ADDITIONAL UPGRADES FOR LINCOLN THEATRE

Solicitation No.: DCAM-15-CS-0094

**Addendum No. 4
Issued: June 4, 2015**

2 E106 FIRST FLOOR PLAN - NEW WORK - POWER SCALE: 1/8" = 1'-0"

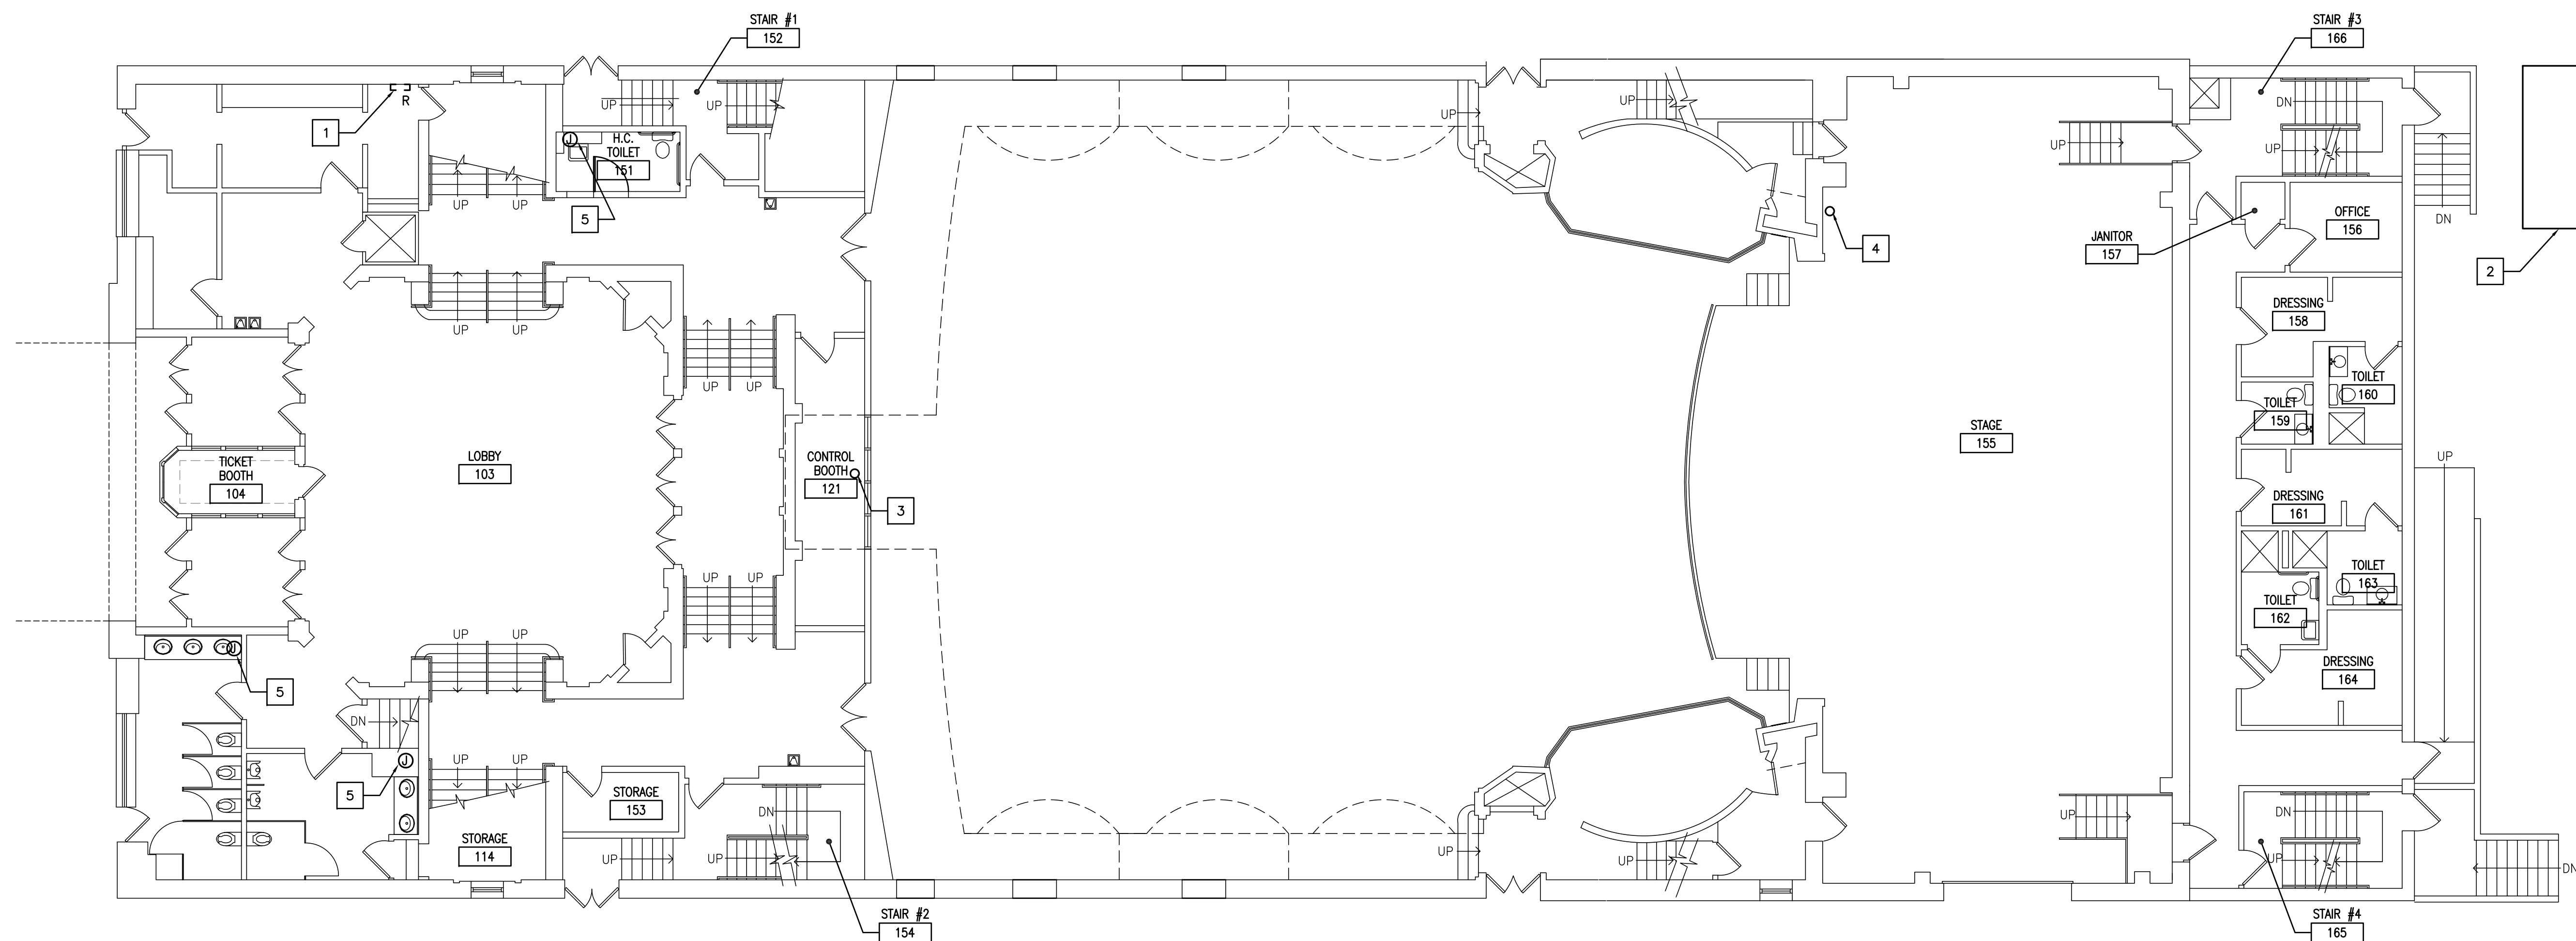
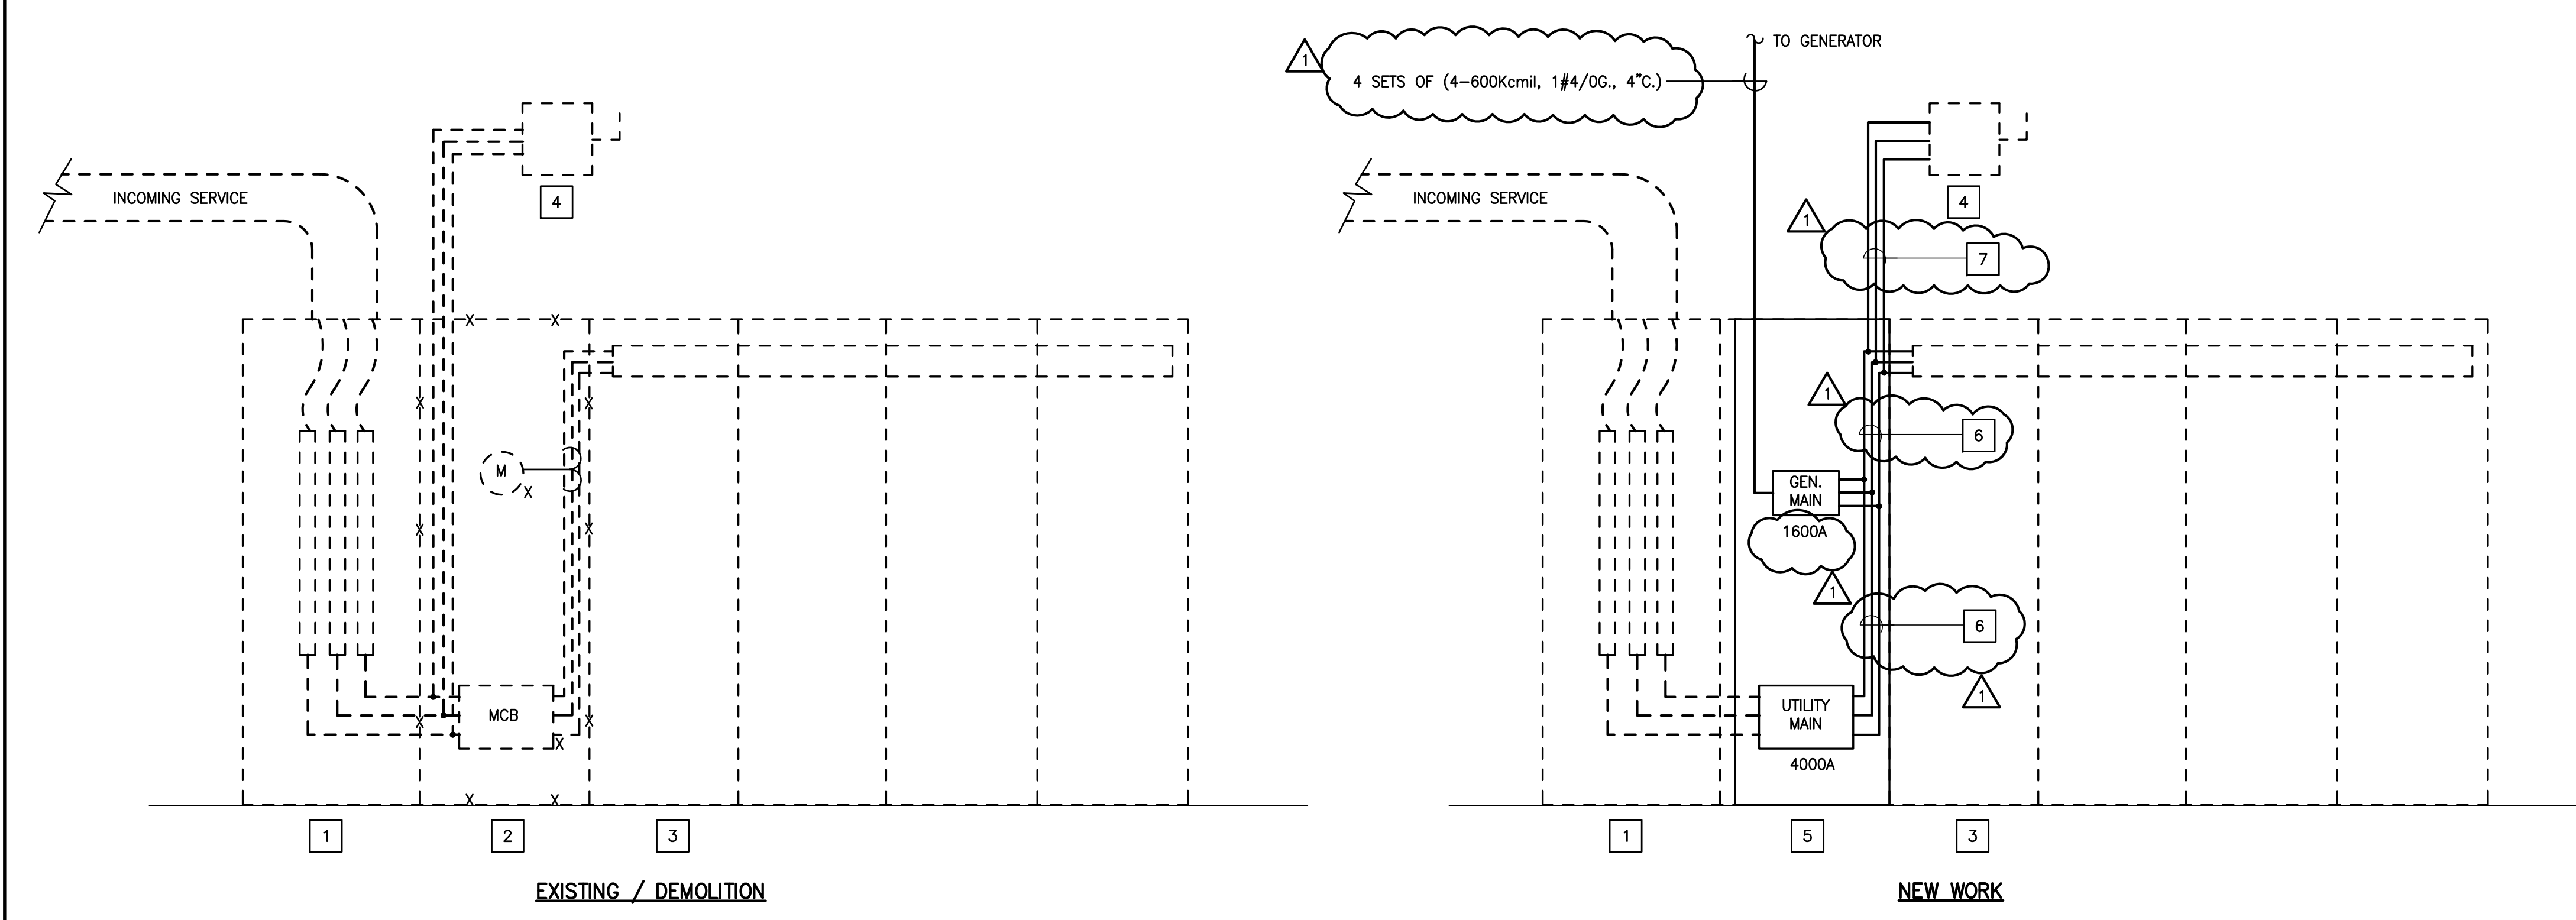
Revised drawings E105 and E106 with Rev.1 of 6/2/2015

Please provide a FAACP drawing	Please see Drawings FB001 and FB101
6	B.1	Page 5 of the RFP, item “v” indicates to test the theatre electrical load & provide a backup generator. Please clarify as to what items are to be on the load of the electrical system for the generator, what type of generator (gas or electric), what size generator and where this generator is to be placed.	Refer to electrical contract documents for generator loads, type, and location. Provide load monitoring for one month during peak summer/winter season, to confirm anticipated building peak average load. For basis of proposal, provide: <ul style="list-style-type: none"> • A 500 kVA generator • 1600A ATS (in lieu of 1200A), and • 4 sets of (4-600 kCMIL, 1#4/0 G, 4” C) instead of 4 sets of (4-350 kCMIL, 1#3/0, 3”C) See Addendum 4, Item No. 2 for revised drawing E105

and E106, Revision 1 6/2/15.
		Also, we are assuming that the generator would be outside, if so, would it be enclosed with a fence? If so are there any specs for the fencing?	No fence is required for the generator set.
7	B.1	Page 5 of the RFP, item “w” indicates to replace the exhaust fans in certain areas. Please indicate what type of exhaust fan and the specifications as to the voltage, size, make and model type.	Refer to construction documents – details and schedules M-701.
8	B.1	The lighting drawing has this “RE” symbol that is not indicated on the drawings. What is this symbol?	Refer to drawing E001 for “RE” symbol definition
9		Is there an estimated price range from the government for this project?	No.
10	B.2	Please confirm the date of the drawings.	The date of the drawings is August 15, 2014.
11	B.2.2	Drawings show a 4000 amp Service for building with a Voltage of 120/208 (Need to verify Voltage), Specs call for a Service entrance rated switch, generator spec calls for a 300 KW Unit. Need to check what is needed,	Refer to response to Question #6.
